PIC16(L)F1826/1827 Family Silicon Errata and Data Sheet Clarification

The PIC16(L)F1826/1827 family devices that you have received conform functionally to the current Device Data Sheet (DS41391D), except for the anomalies described in this document.

FIGURE 1: INSTRUCTION CYCLE DELAY CALCULATION EXAMPLE

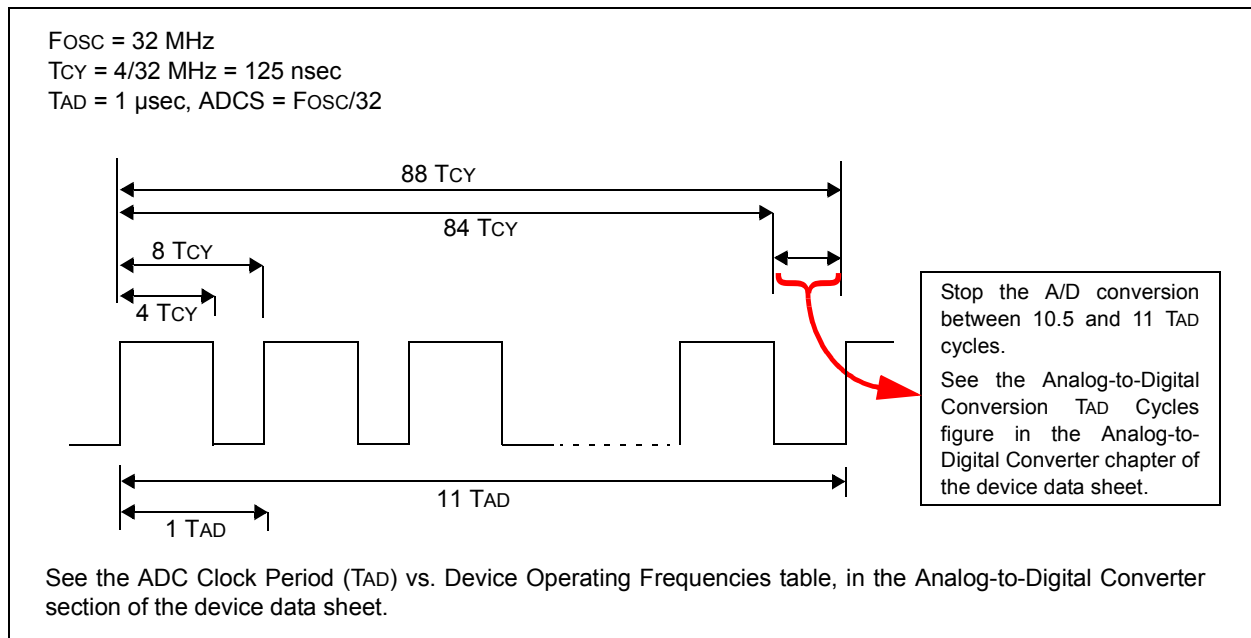
An ADC conversion may not complete under these conditions:

1. When F_{OSC} is greater than 8 MHz and it is the clock source used for the ADC converter.
2. The ADC is operating from its dedicated internal FRC oscillator and the device is not in Sleep mode (any F_{OSC} frequency).

When this occurs, the ADC Interrupt Flag (ADIF) does not get set, the $\overline{GO/DONE}$ bit does not get cleared, and the conversion result does not get loaded into the ADRESH and ADRESL result registers.

Method 3: This method is provided if the application cannot use Sleep mode and requires continuous operation at frequencies above 8 MHz. This method requires early termination of an ADC conversion. Provide a fixed time delay in software to stop the A-to-D conversion manually, after all ten bits are converted, but before the conversion would complete automatically. The conversion is stopped by clearing the $\overline{GO/DONE}$ bit in software. The $\overline{GO/DONE}$ bit must be cleared during the last $\frac{1}{2}$ TAD cycle, before the conversion would have completed automatically. Refer to Figure 1 for details.

In Figure 1, 88 instruction cycles (T_{CY}) will be required to complete the full conversion. Each TAD cycle consists of eight T_{CY} periods. A fixed delay is provided to stop the A/D conversion after 86 instruction cycles and terminate the conversion at the correct time as shown in the figure above.

Note: The exact delay time will depend on the TAD divisor (ADCS) selection. The Tcy counts shown in the timing diagram above apply to this example only. Refer to [Table 3](#) for the required delay counts for other configurations.
